Engineering comments for Piling No. 1 & 2 have been provided in this document for 1st review.

EL PASO COUNTY PLANNING & COMMUNITY DEVELOPMENT NUMBER: ~~SF26X~~

IRON RIDGE FIGLING NO. 1 & 2

LEGEND

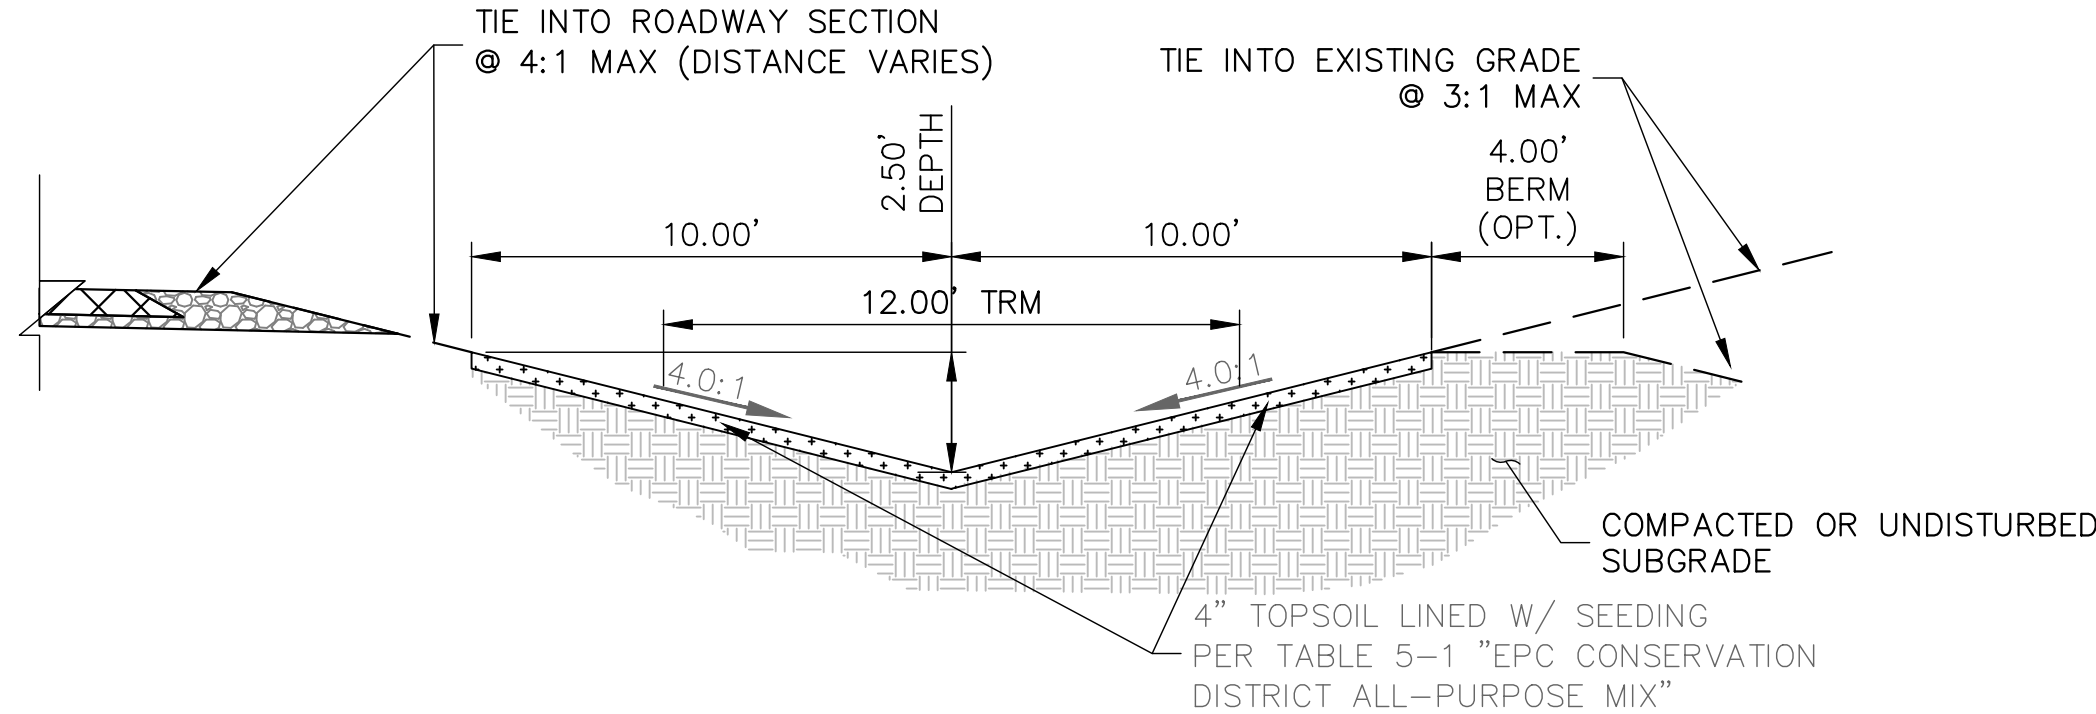
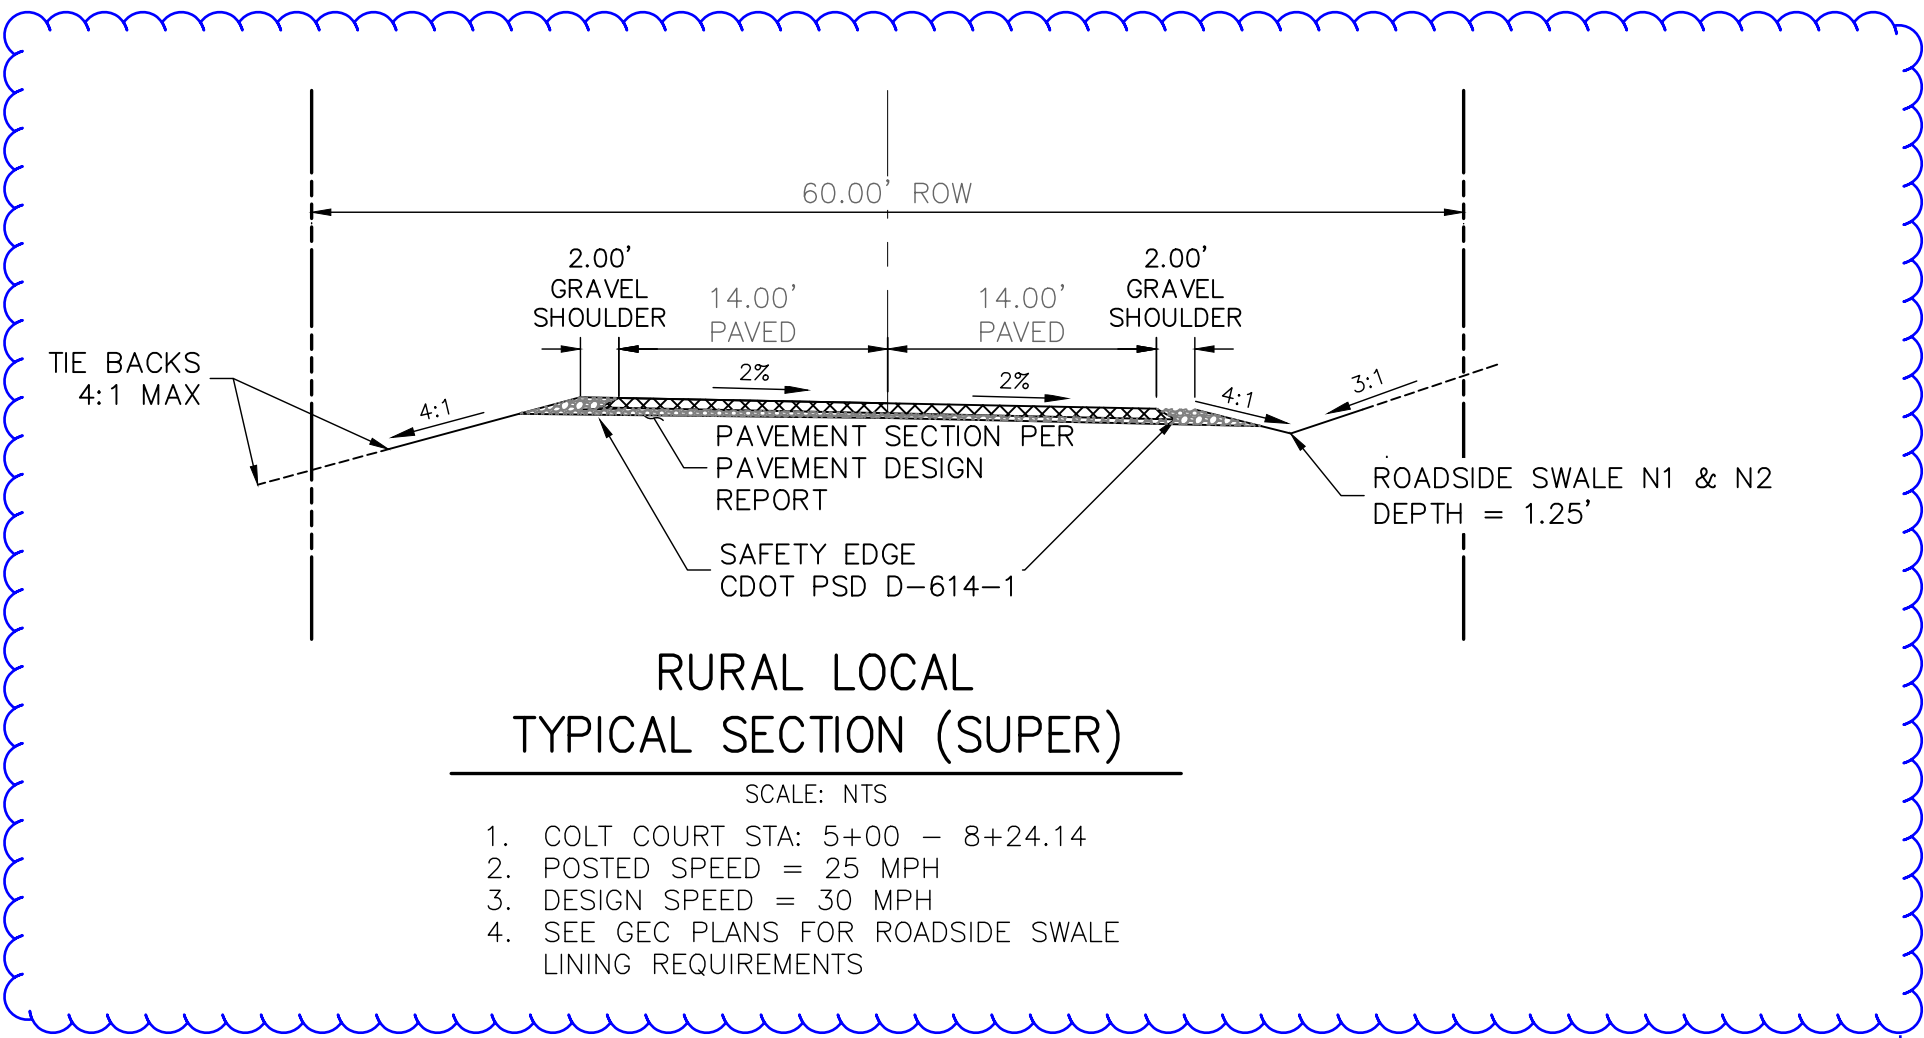
Revise to match line work on GEC sheets

### COLT COURT (1) STA 15+00.00 TO 21+81.30

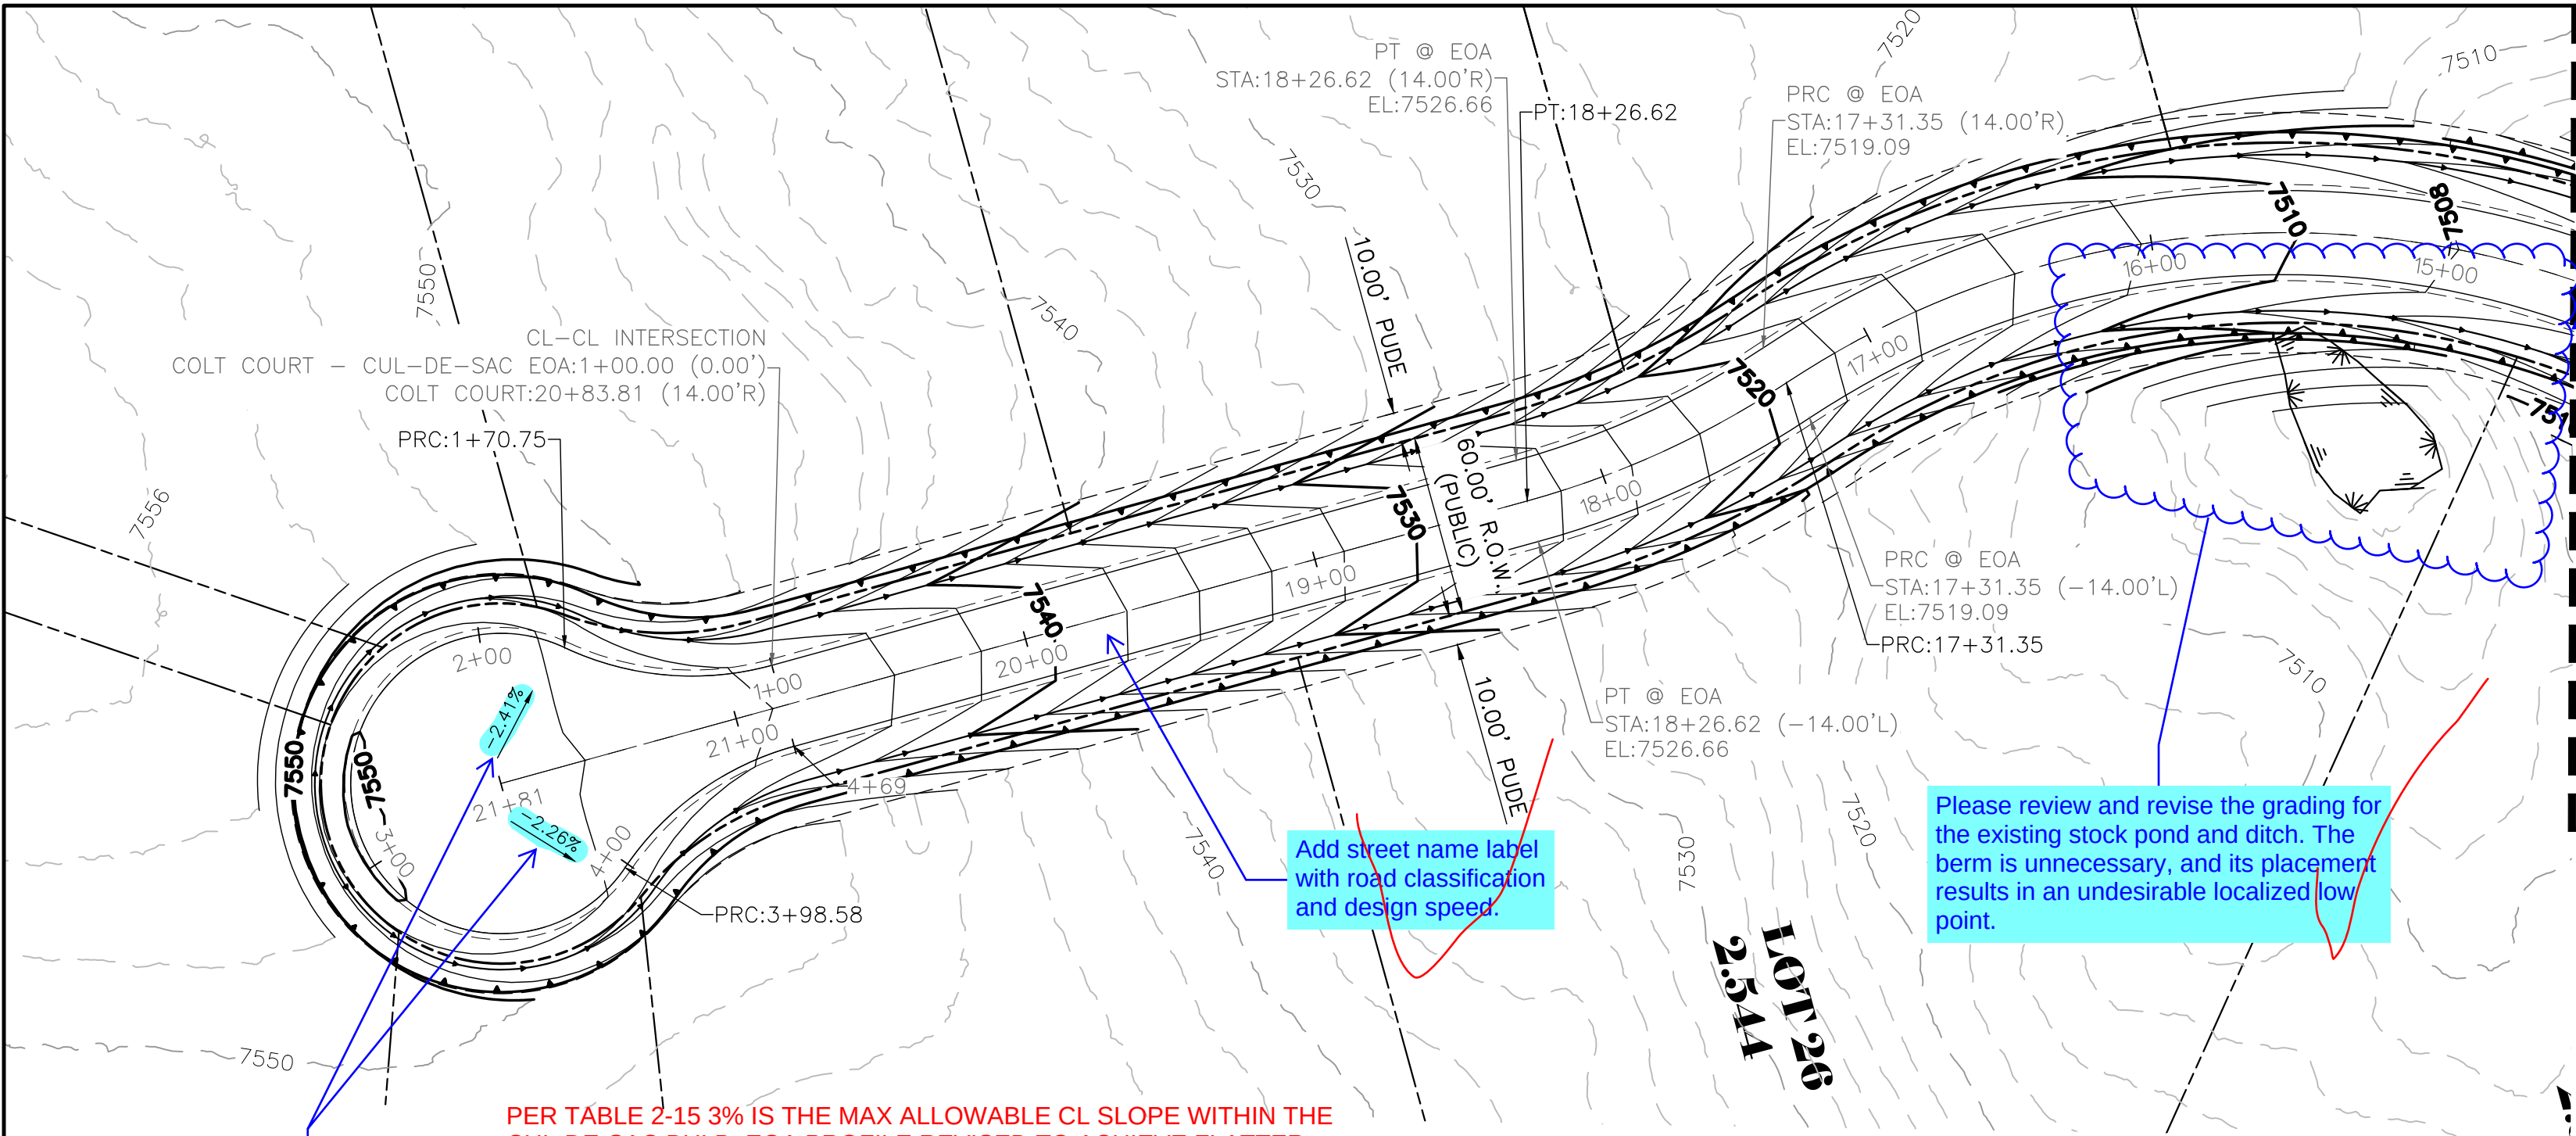
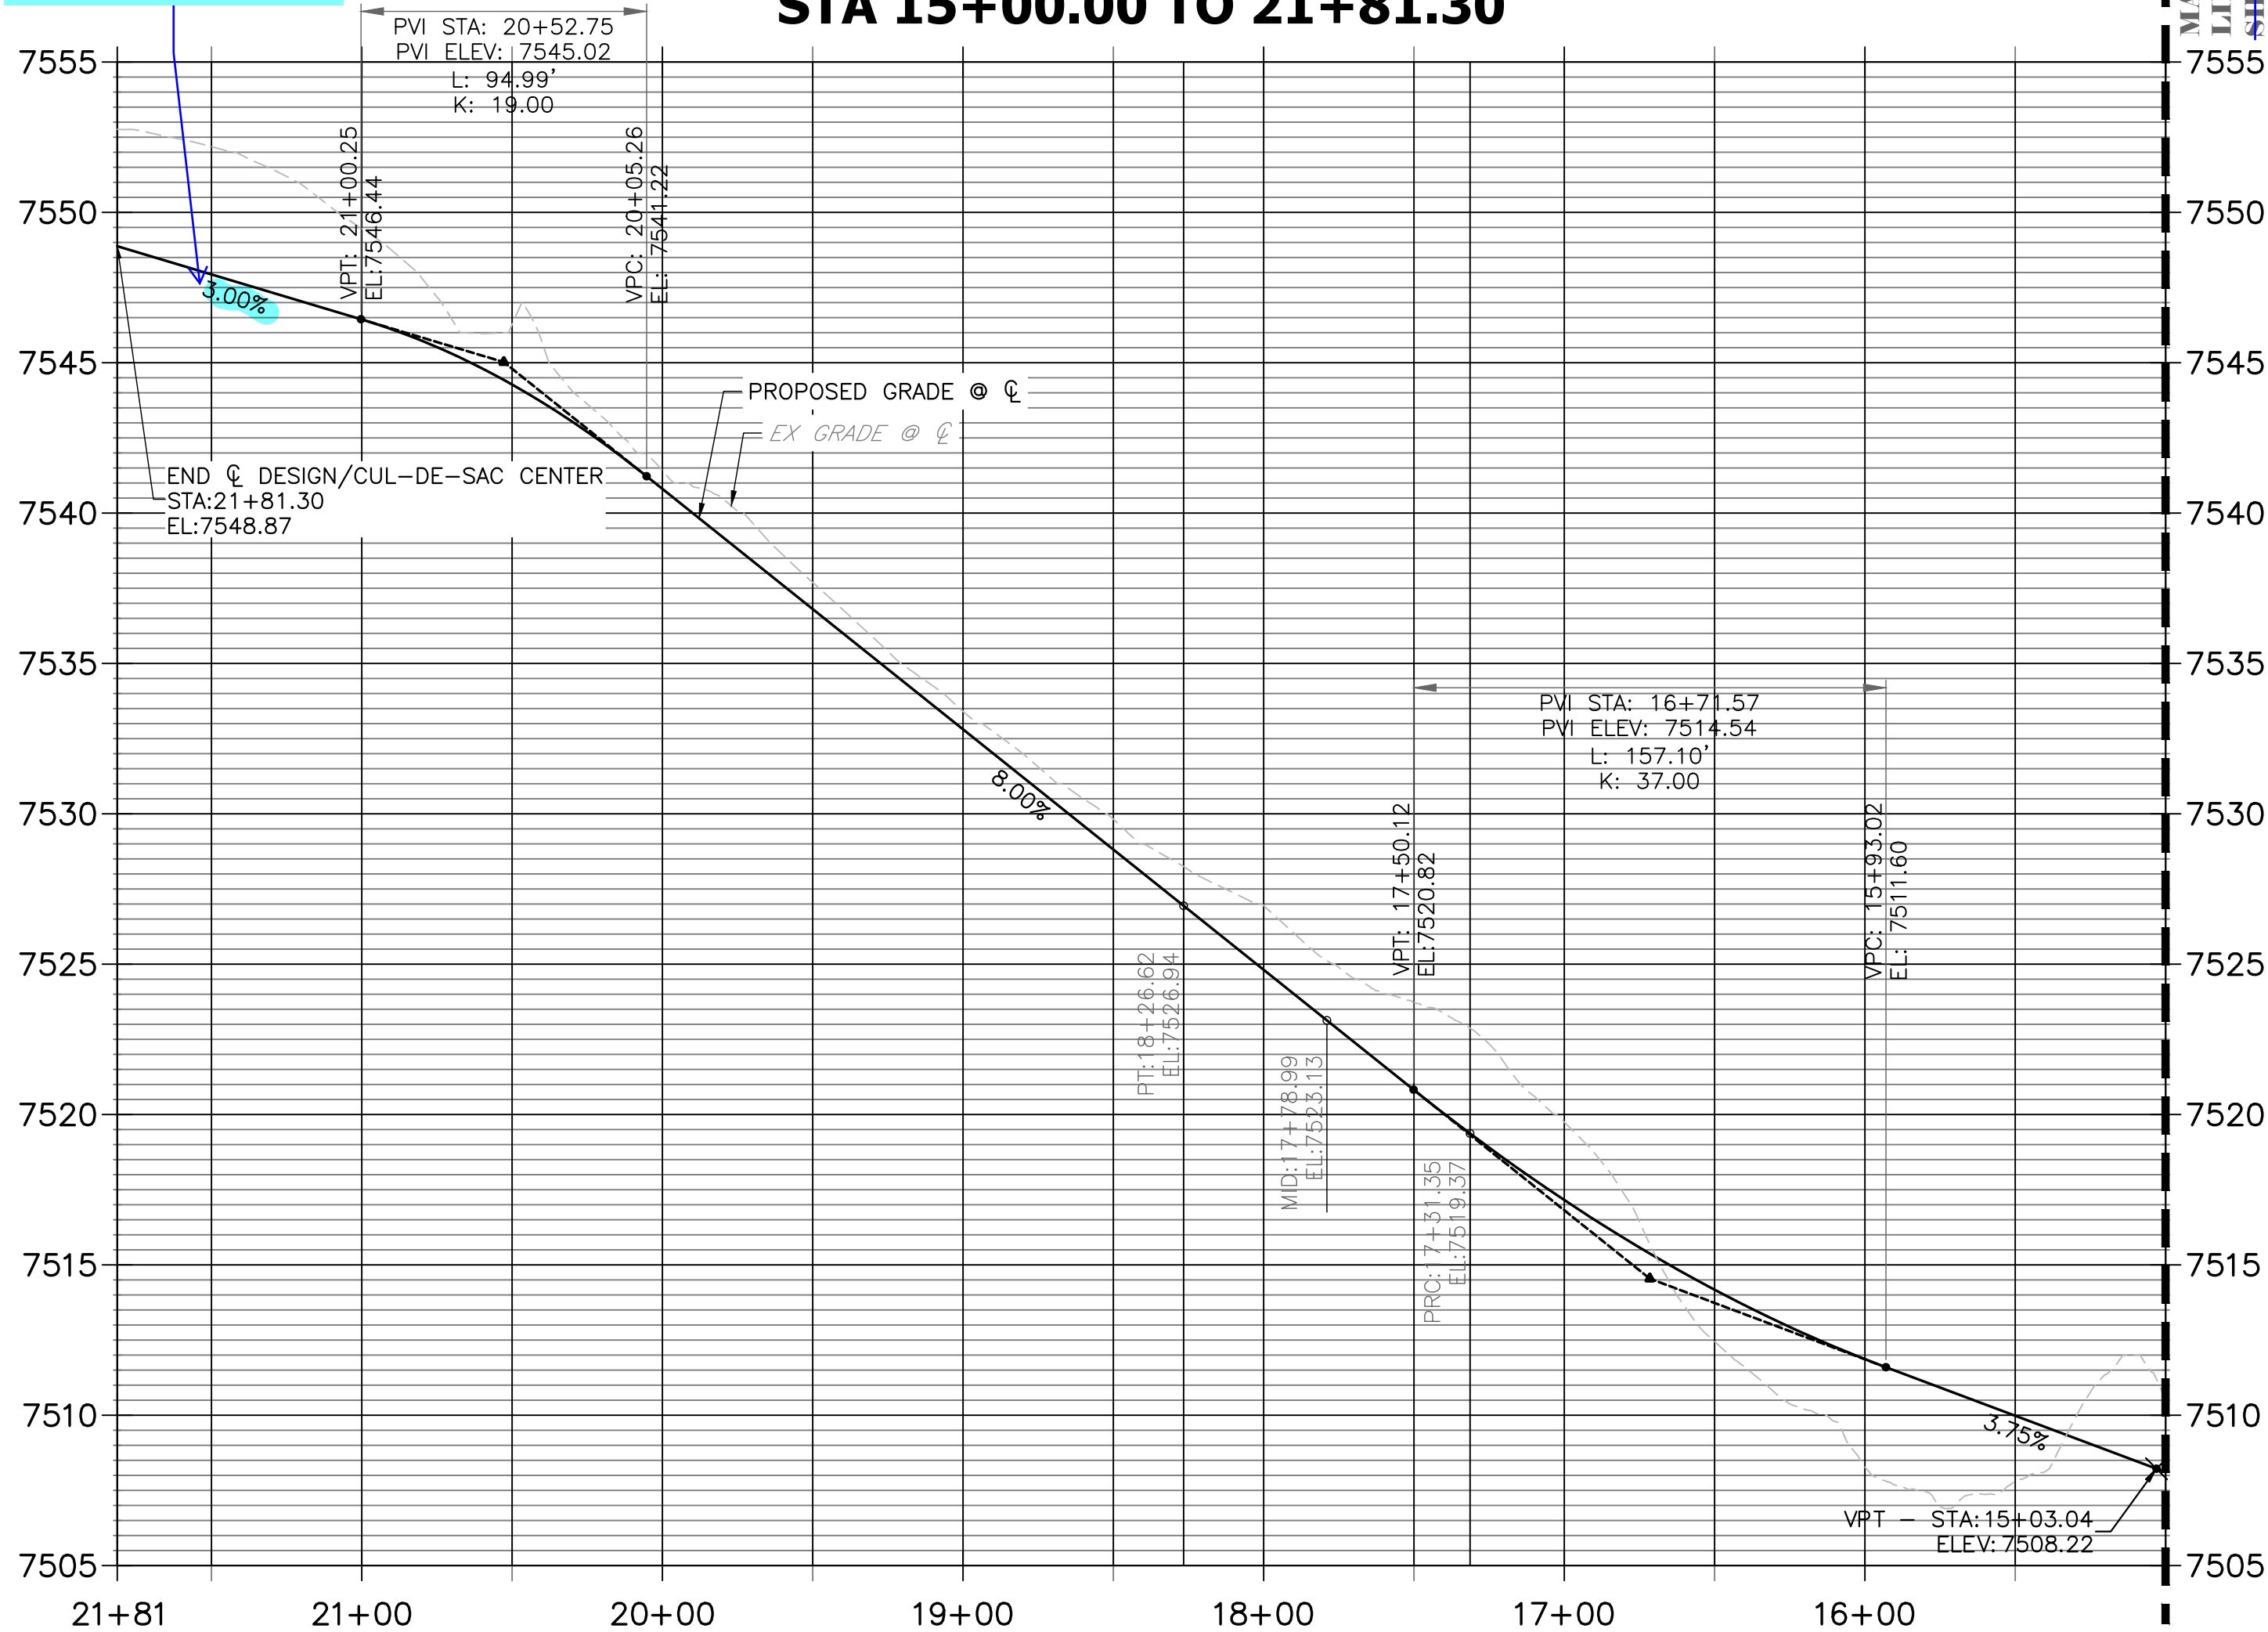
Per ECM Figure 2-31 Typical Cul-de-Sac Requirements (Urban and Rural), maximum slope for rural cul-de-sacs is 2%. Revise grading.

PER TABLE 2-15 3% IS THE MAX ALLOWABLE CL SLOPE WITHIN THE CUL-DE-SAC BULB. EOA PROFILE REVISED TO ACHIEVE FLATTER CROSS SLOPES

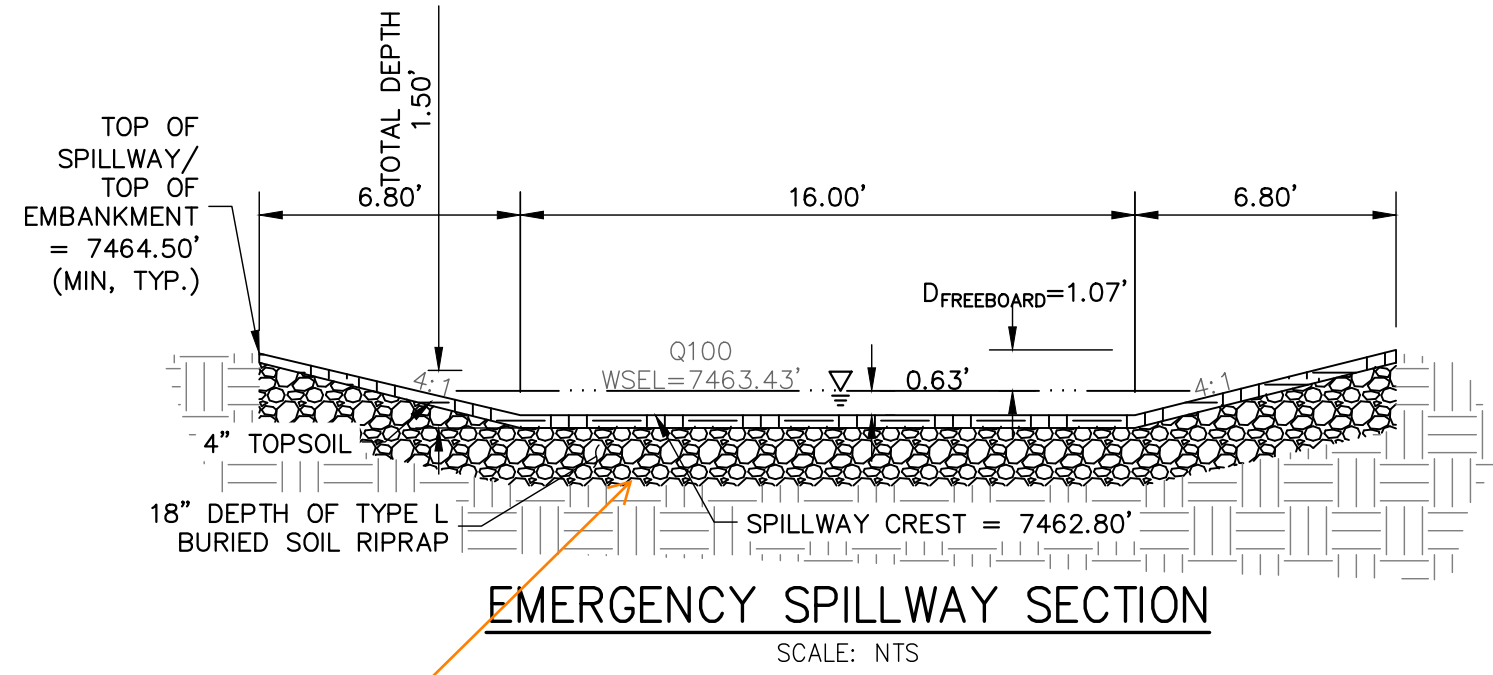
Provide bedding material/geotextile fabric between riprap and sub-base (per DCMv1 - Chap 10.10.5).

THIS SECTION DOES NOT APPLY TO SOIL RIPRAP, IT APPLIES TO PLAIN RIPRAP. SOIL RIPRAP BEDDING IS GENERALLY NOT REQUIRED OR RECOMMENDED BY MHFD.
